UNITED STATES PATENT AND TRADEMARK OFFICE

Office Action Summary

10/046,066

DETAILED ACTION

EXHIBIT A

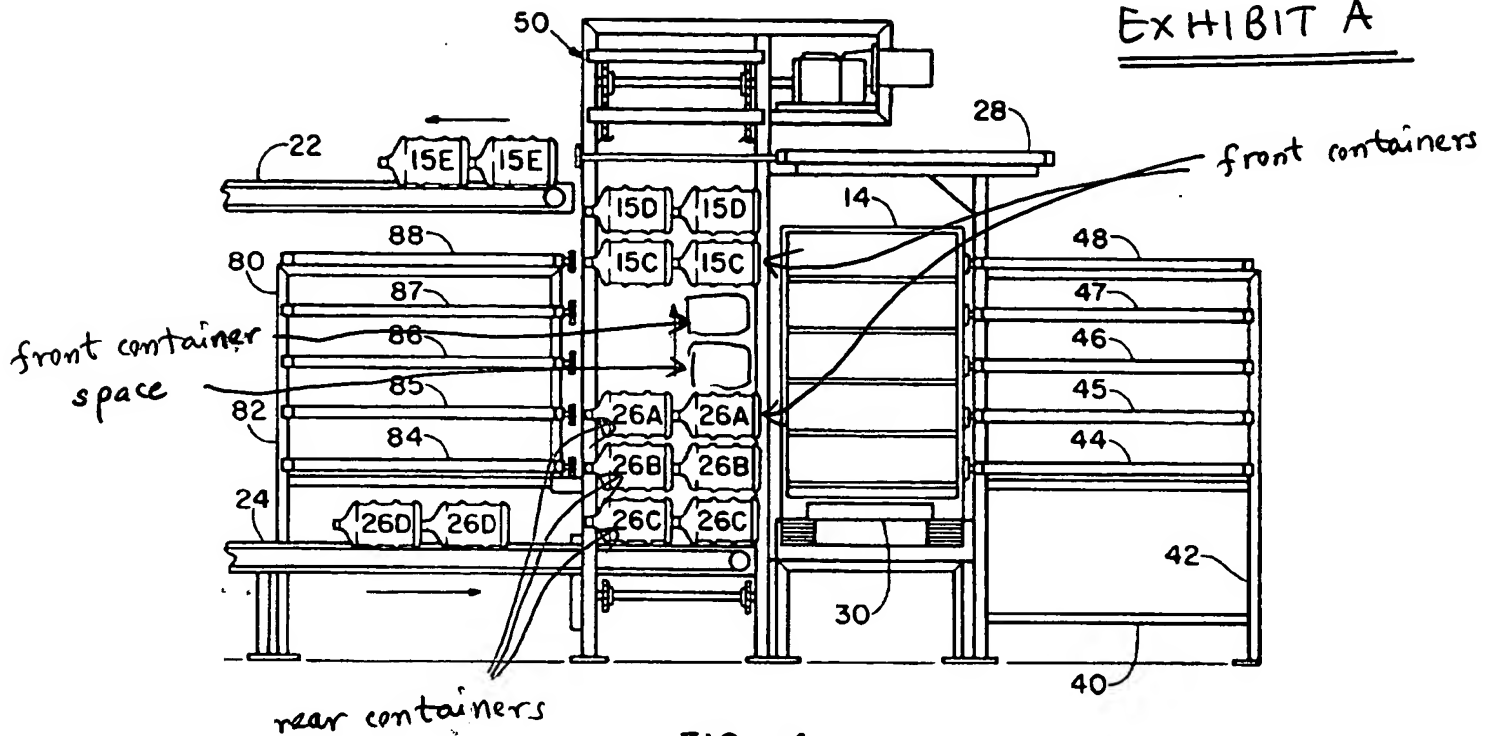
Simmons et al. (5,895,195) discloses a device for unloading a rack for storing containers, comprising a rack having a first space storing a front container (15C, 26A, 26B, 26C) (see Exhibit A, Fig. 4), a second space storing a rear container, the first container blocking the second container, the device having an extending arm (see Exhibit A) that extends through the front space into the rear space.

FIG. 5

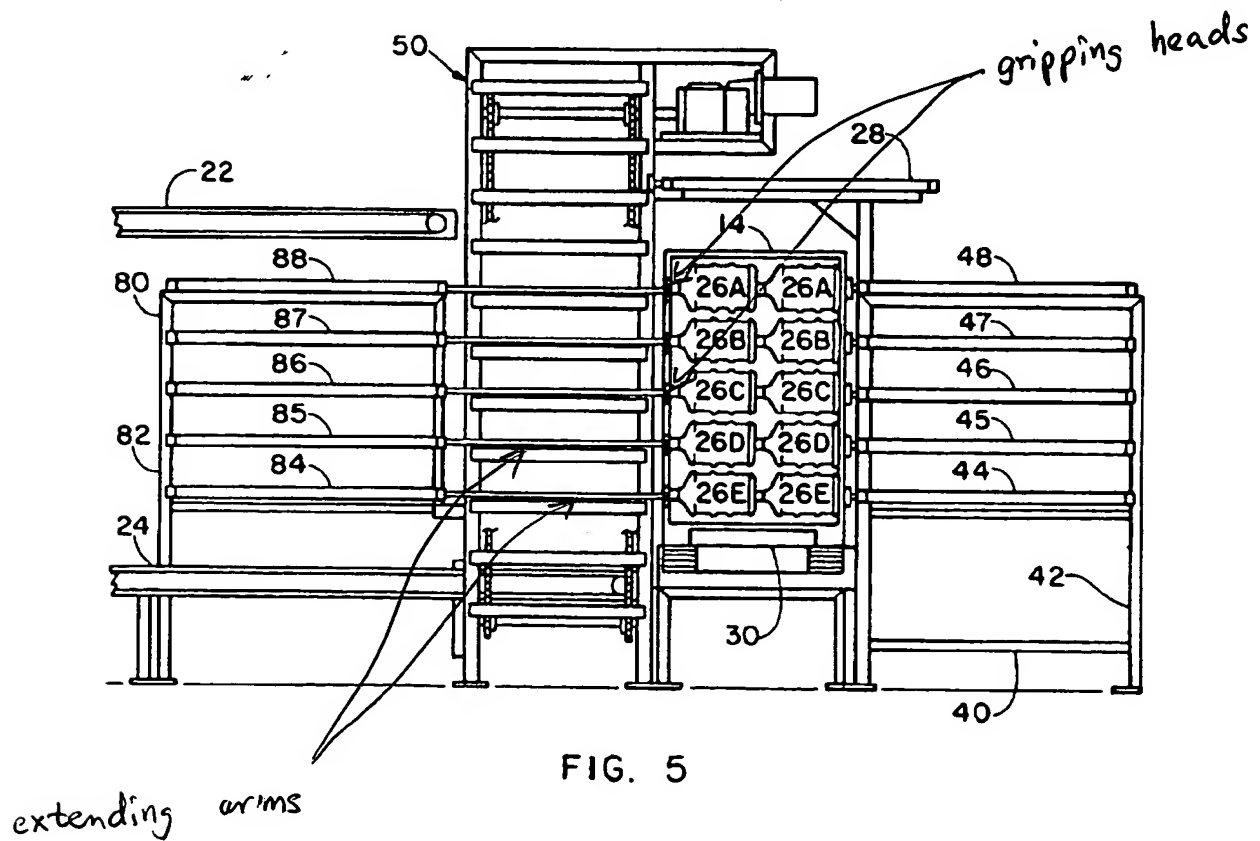
Re claim 23, the extending arm has an un-extended length (see Fig. 4) and a fully extended length (see Fig. 5).

FIG. 13

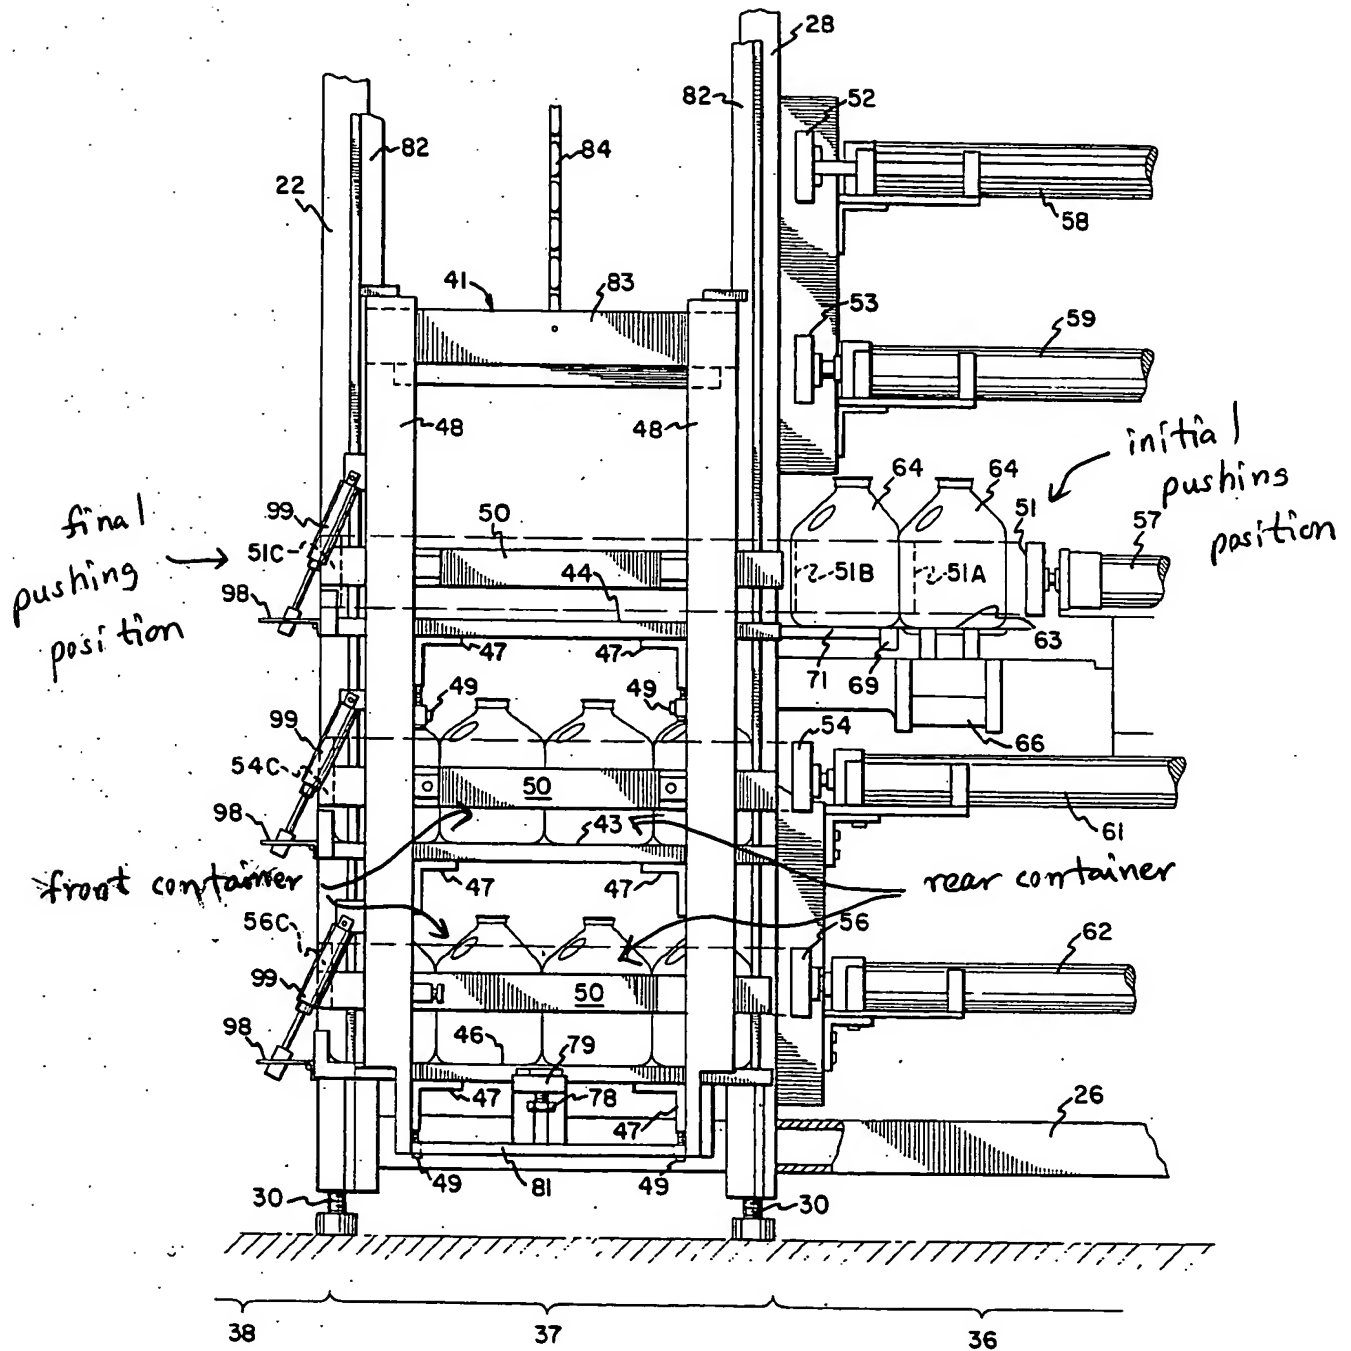
Butterly, Jr. et al. (4,634,33) discloses a device for unloading containers comprising a rack (see Exhibit C of Fig. 13) having a first space storing a front container (64), a second space storing a rear container, the first container blocking the second container, the device having an extending arm (51,57,54,61,56,62) that extends through the front space into the rear space. It is pointed out that the pushers can extend from the initial position (15A) to the final position (15C) (see Fig. 13) (Col 12, lines 3-31).

Re claim 23, the extending arm has an un-extended length (15A position) and a fully extended length (15C position).
